**DANE COUNTY DEPT. OF
PUBLIC WORKS, HIGHWAY &
TRANSPORTATION**

ADDENDUM 3

RFB NO. 316003 - ADDENDUM NO. 3

CONCRETE FLATWORK REMOVAL AND REPLACEMENT

Drawing
 1

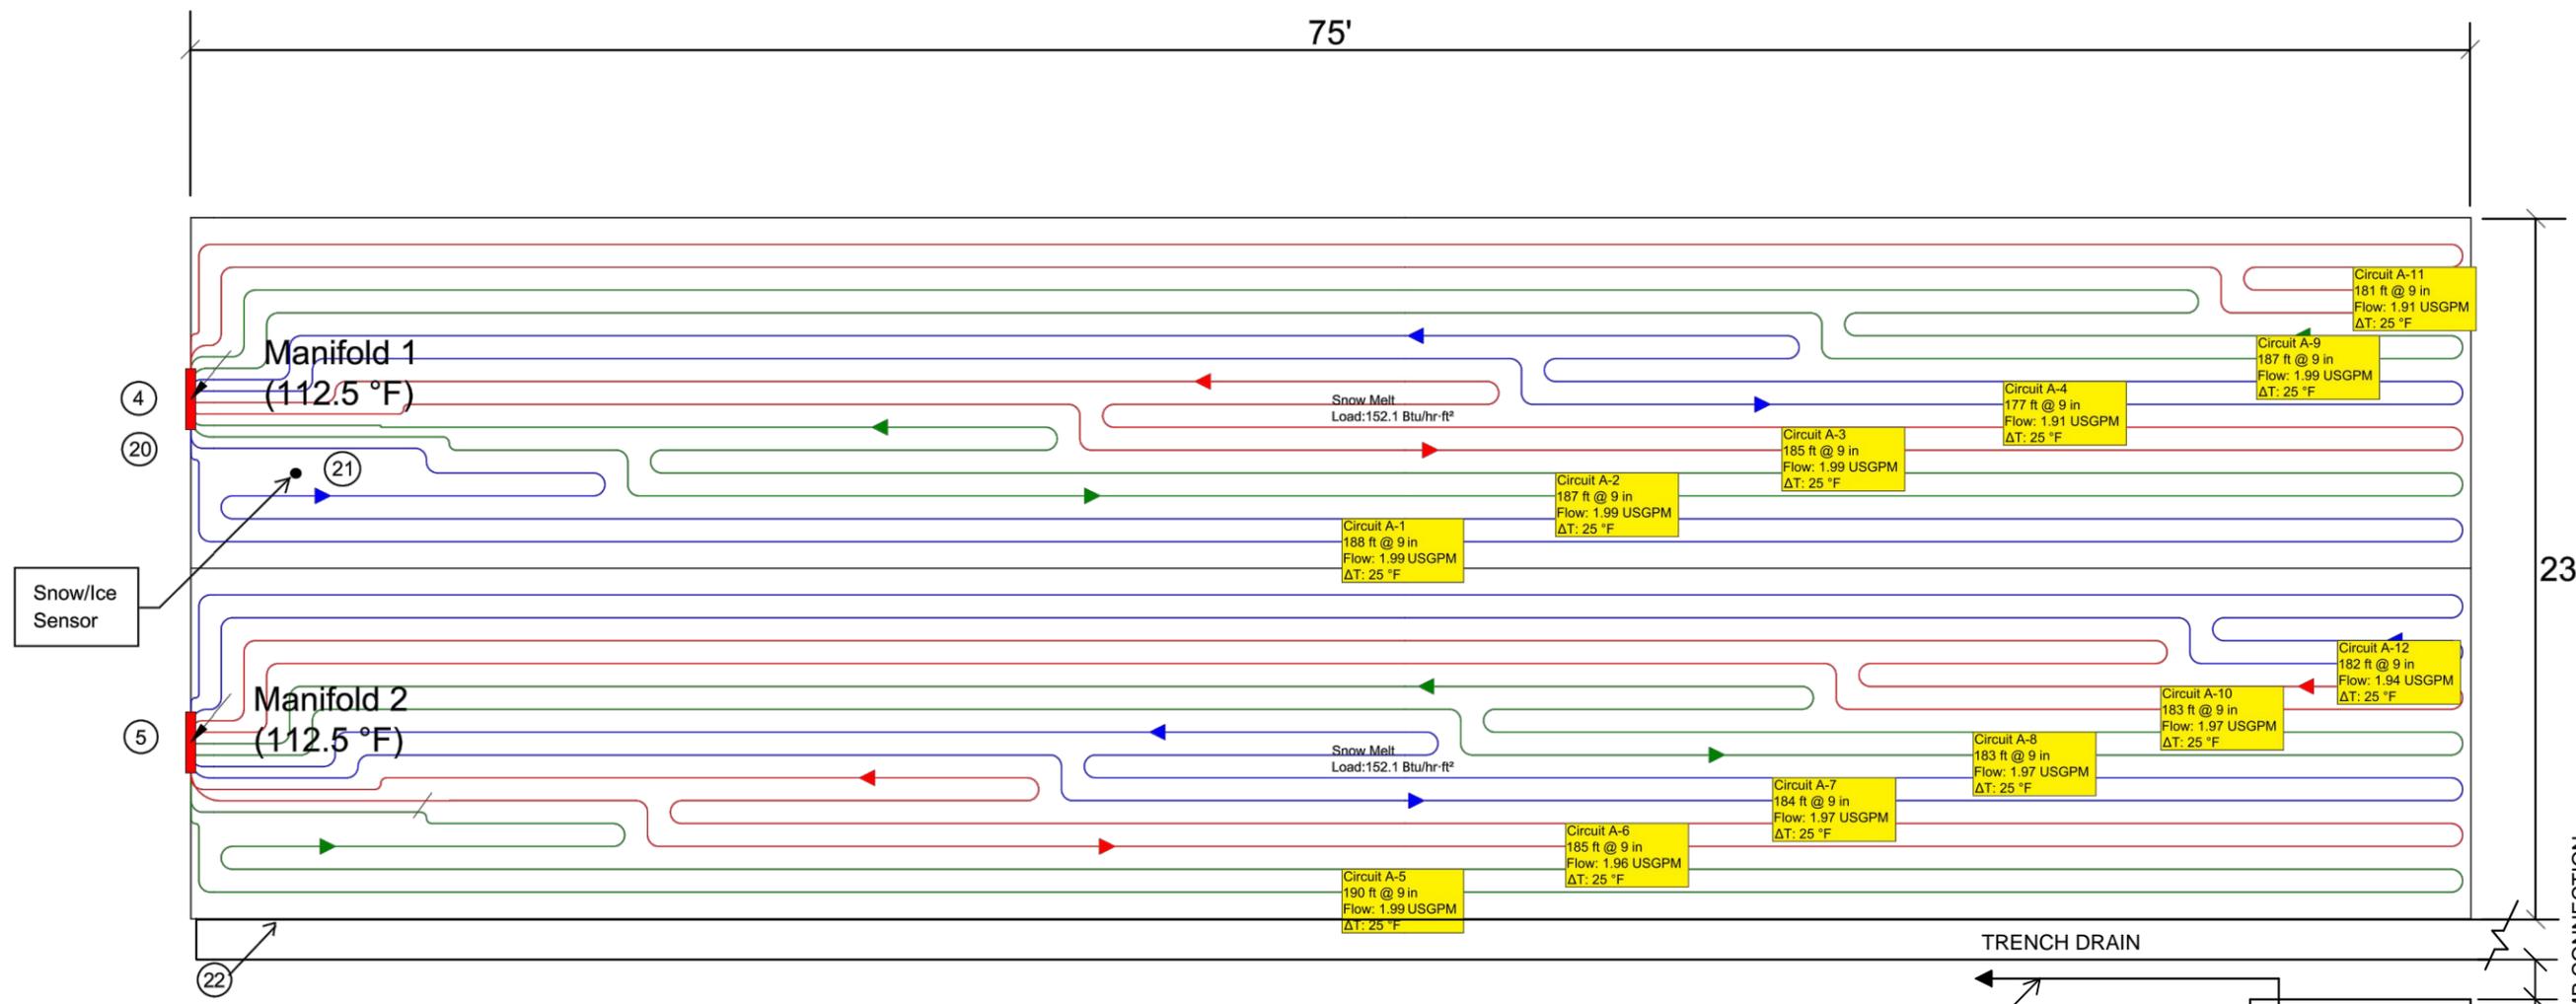
Delete current Drawing P1 – Snow Melt Tubing Layout and replace with new Drawing 1 – Snow Melt Tubing Layout – Base Bid, issued with this Addendum.

Design By: GJ	Drawn By: JRL	Approved By: RLS	Revisions	CONCRETE FLATWORK REMOVAL AND REPLACEMENT CITY-COUNTY BUILDING 210 MARTIN LUTHER KING JR BLVD MADISON, WISCONSIN	Drawing <u>1A</u>
Bid No.: 316003	Date: 4/6/18	Scale: AS NOTED

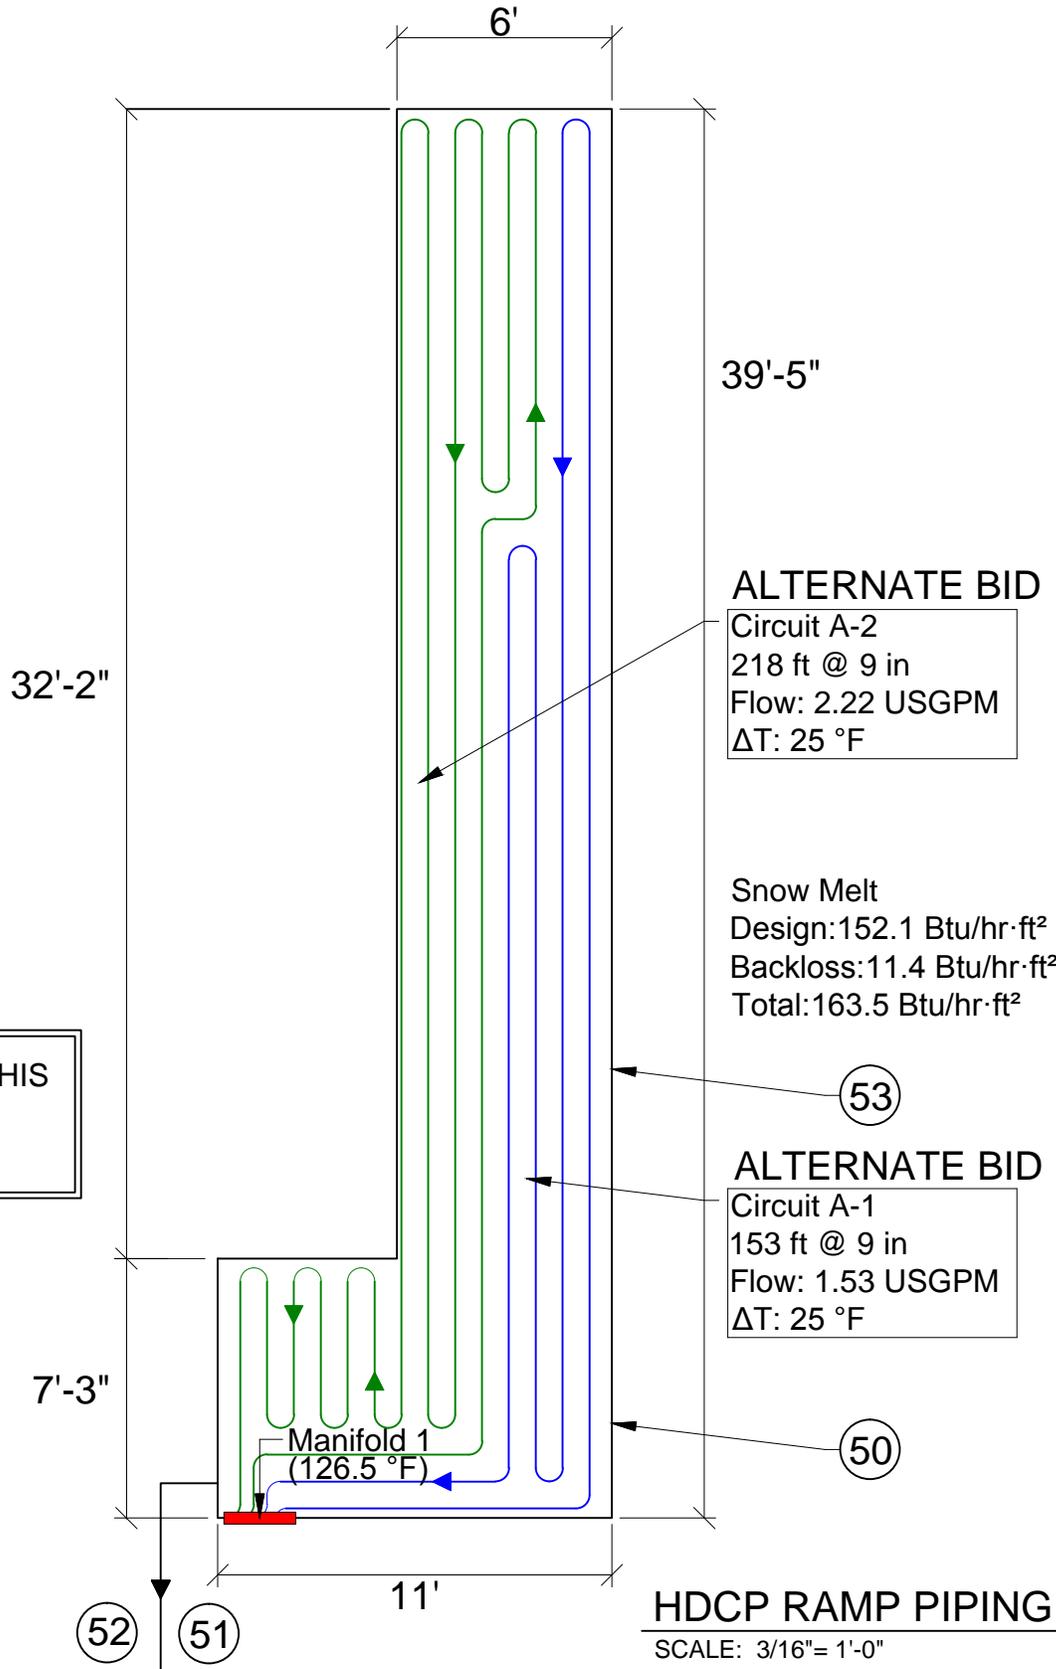
Add new Drawing 1A – Snow Melt Tubing Layout – Alternate Bid, issued with this Addendum.

PARTIAL MECH. RM FLOOR PLAN GR 100

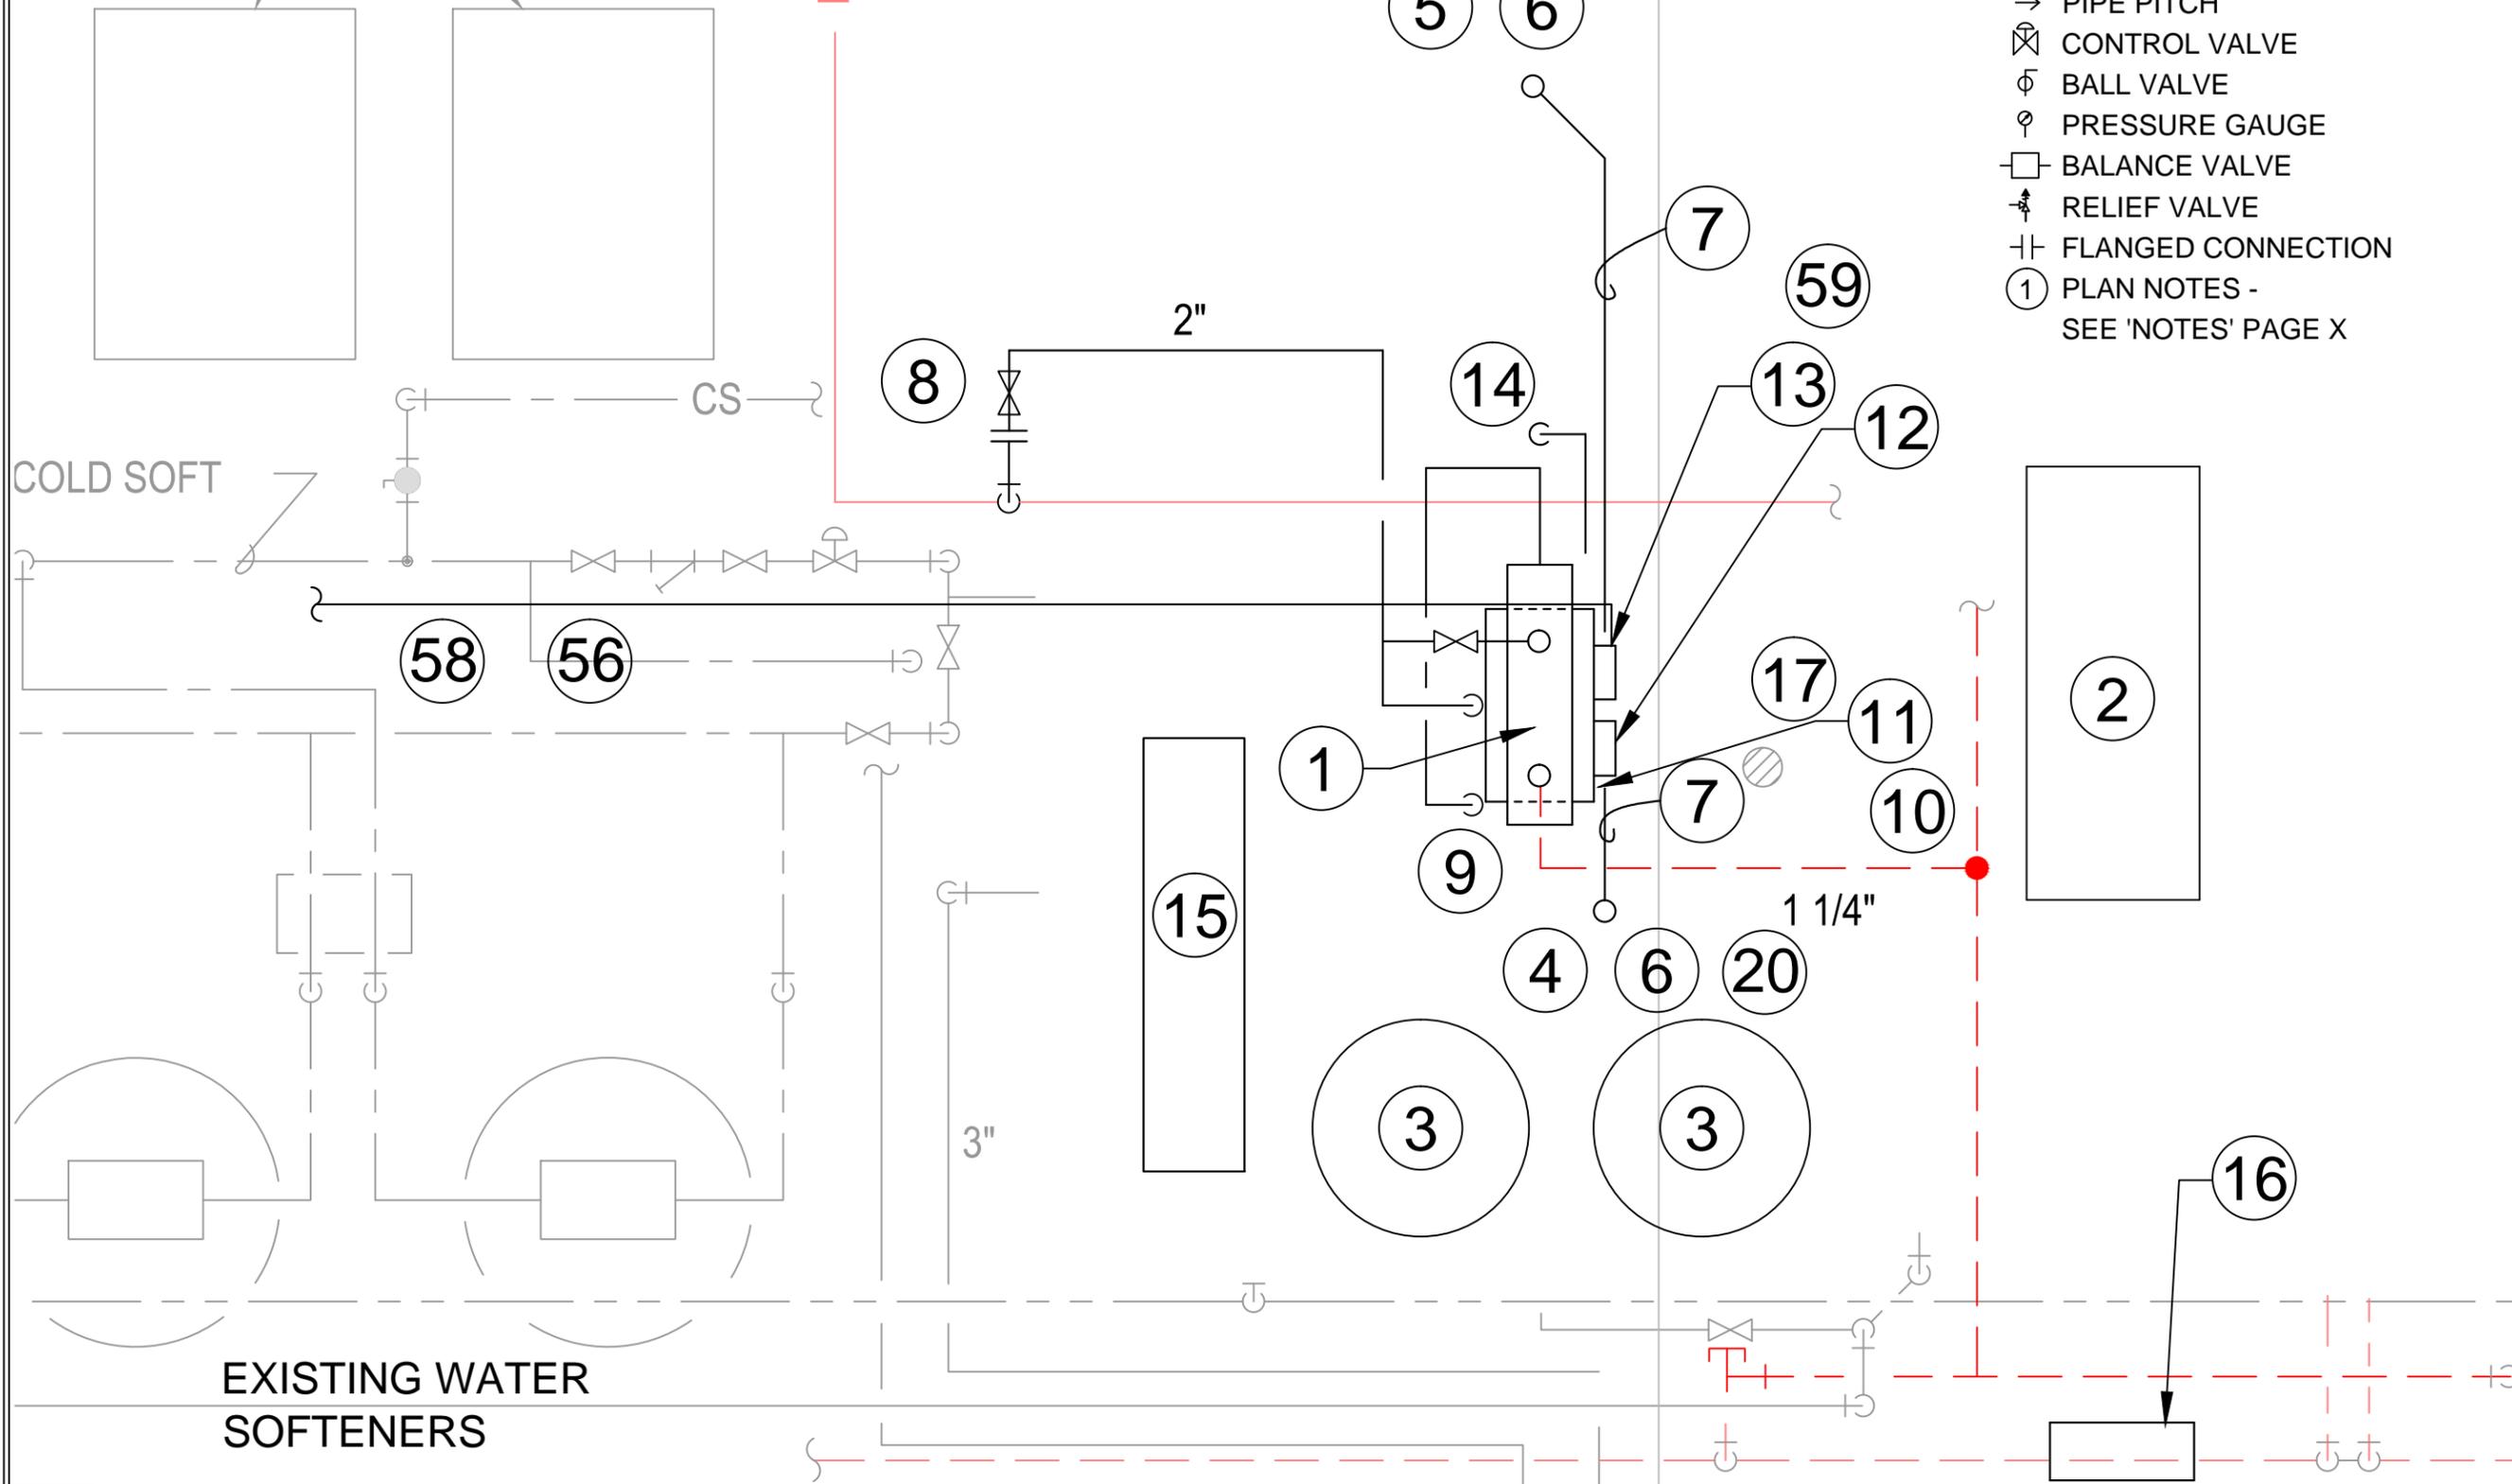
Delete current Drawing 3 - Partial Mechanical Room Floor Plan and replace with new Drawing 3 - Partial Mechanical Room Floor Plan, issued with this Addendum.

ADENDUM #2 - BASE BID AND ALTERNATE BID
CONCRETE FLATWORK REMOVAL
AND REPLACEMENT
CITY-COUNTY BUILDING
210 MARTIN LUTHER KING JR BLVD
MADISON, WISCONSIN

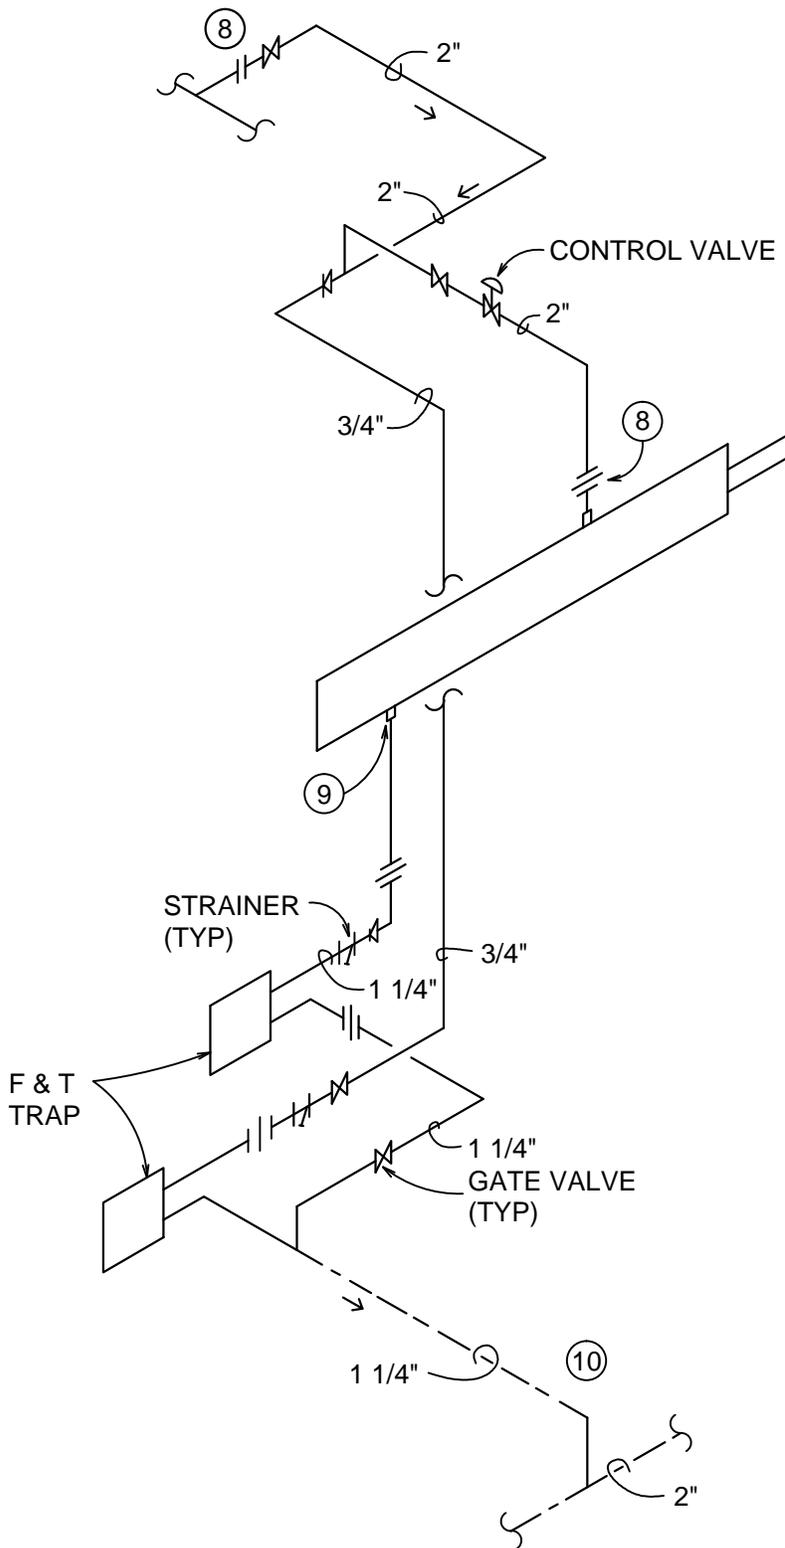
Delete current Drawing 4 – Glycol / Water Piping Detail and replace with new Drawing 4 – Glycol / Water Piping Detail, issued with this Addendum.

Drawing
5

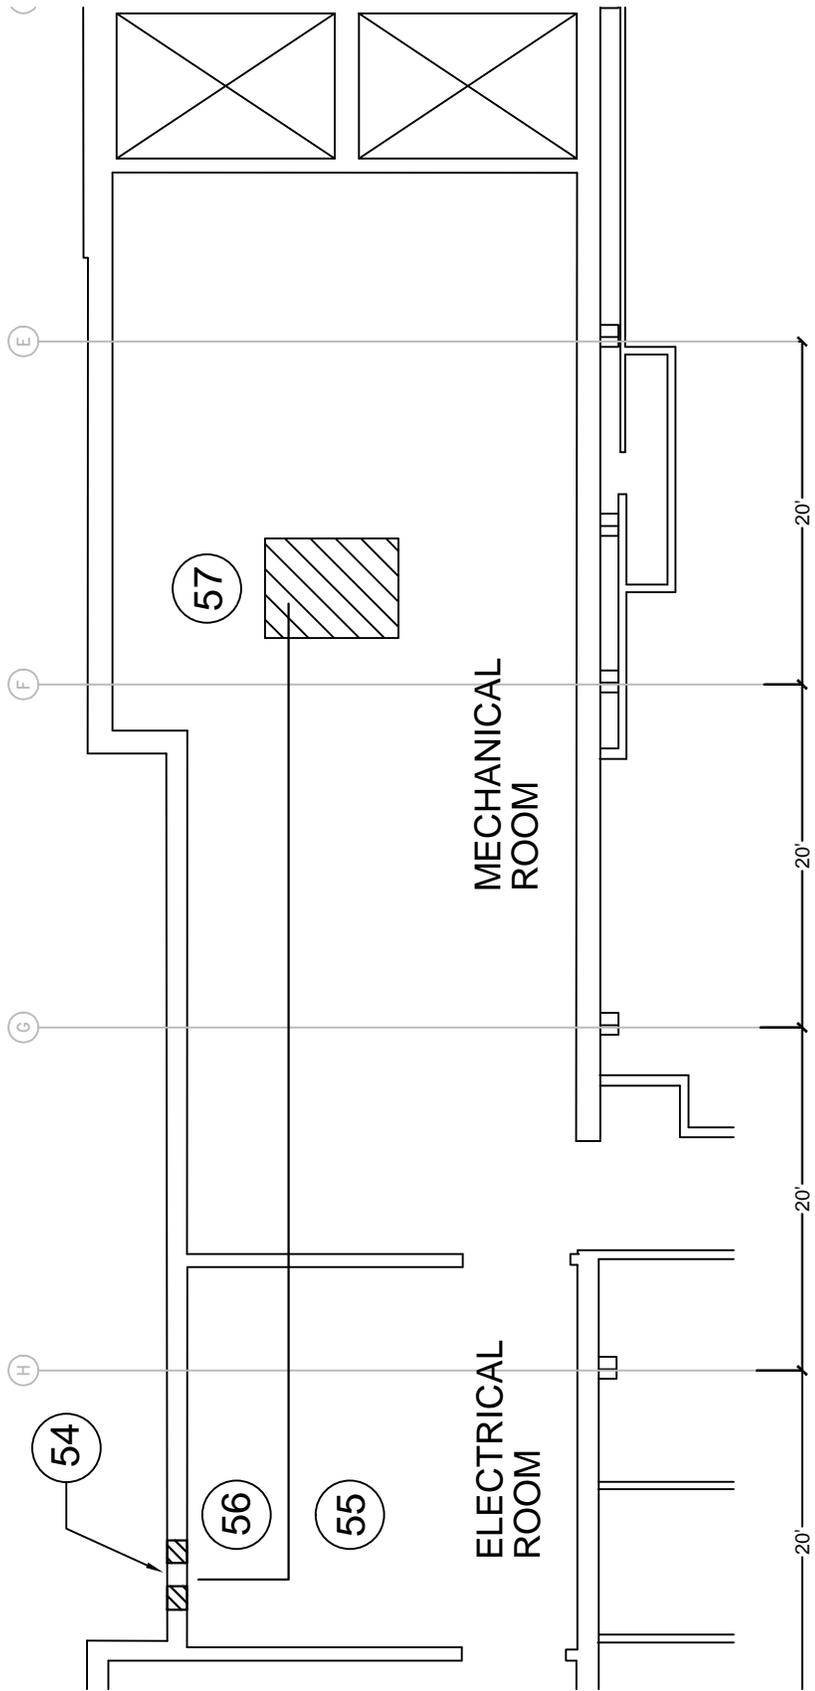
Delete current Drawing 5 – Steam Piping Detail and replace with new Drawing 5 – Steam Piping Detail, issued with this Addendum.
